DELAYED CALL TRUNK, SERVICE OBSERVING ACCESS CIRCUIT
AND OPERATOR SERVICE TRUNK
OPERATIONAL AND TRANSMISSION TESTS AND ADJUSTMENTS
TRAFFIC SERVICE POSITION SYSTEM NO. 1

1.01 This appendix covers the implementation of the Directory Charge Recording (DCR) feature into the Traffic Service Position System (TSPS) No. 1.

**SECTION 250-103-501PT
APPENDIX 1**

**ACD/DCR Sectionalized Maintenance
Fig. 2**

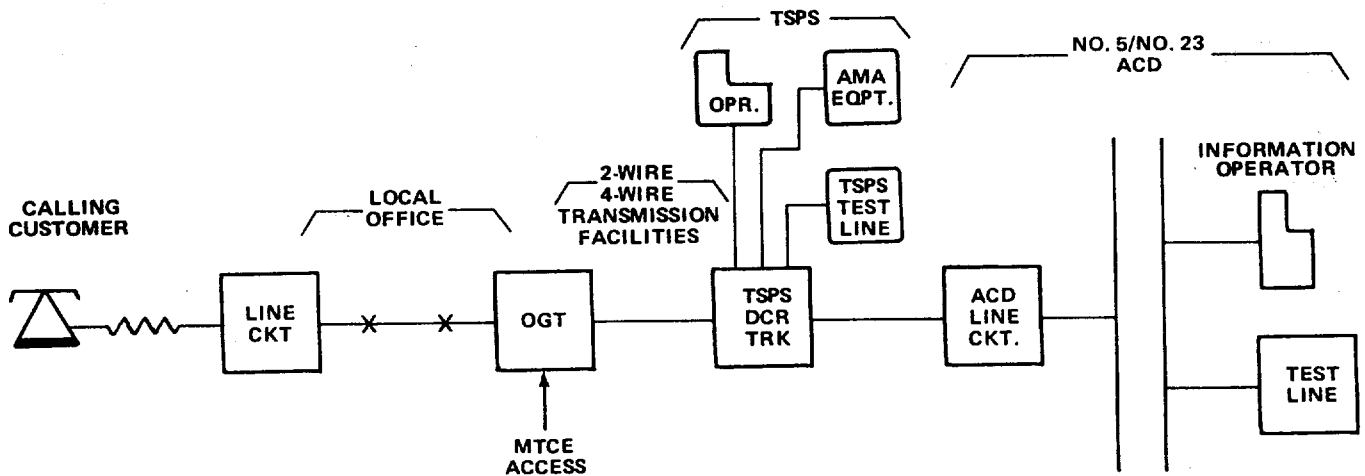
2.03 To circumvent the above problems the maintenance procedures are modified (see Fig. 2). The craftsperson at the local office will access an outgoing trunk and seize forward towards the TSPS DCR trunk. Upon recognition of the DCR trunk seizure, TSPS will attach a multifrequency (MF) receiver or operator to the connection depending upon whether the trunk group is Automatic Number Identification (ANI) or Operator Number Identification (ONI), respectively.

2.04 In the case of ANI, MF pulses followed by a continuous test signal of TOUCH-TONE frequency 16 are forwarded to TSPS. These tests are accomplished through special testing equipment at the local office test frame in conjunction with a portable auxiliary test set (SD-99391-01) used by the local office craftsperson.
